Memo

Re: Planning application ref: PL/26/0352

Address: WARREN CREEK, THE WARREN, CAVERSHAM, READING, RG4 7TQ

Description: Discharge of conditions 3 (materials), 4 (scheme to mitigate flood risk impact), 6 (schedule for removal of existing structures), 7 (maintenance of the flood voids), 9 (sustainable drainage strategy), 11 (demolition and construction method statement), 16 (programme of archaeological work), 17 (hard and soft landscaping), 18 (arboricultural method statement and tree protection plan), 19 (construction environmental management plan), 20 (external lighting scheme), 21 (noise assessment of the proposed mechanical plant) and 22 (privacy measures) of planning permission PL/24/1614, as granted on 12/11/2025.

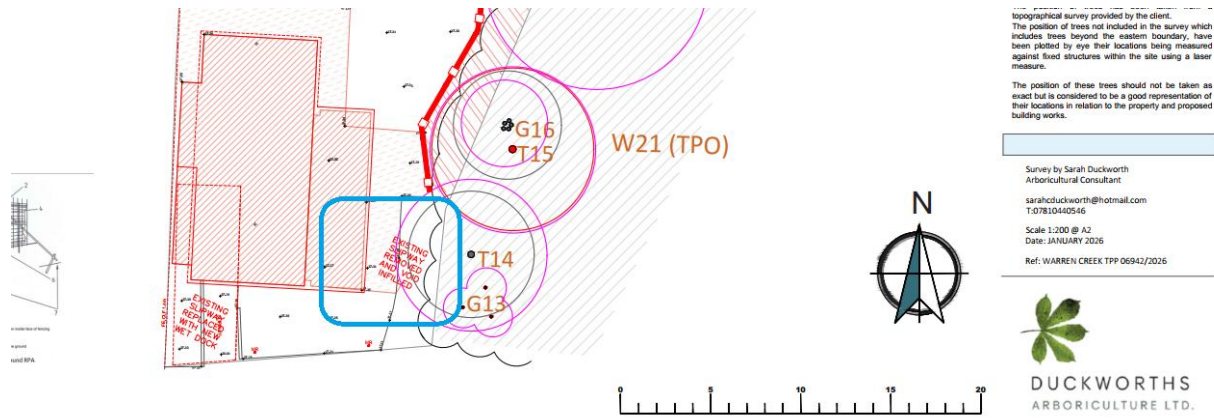
There is no reference in this document to the methodology involved for the infilling of the slipway – shown in blue box below:

Clarity is required on whether this is still proposed and if so what measures are required to protect the Thames in this location
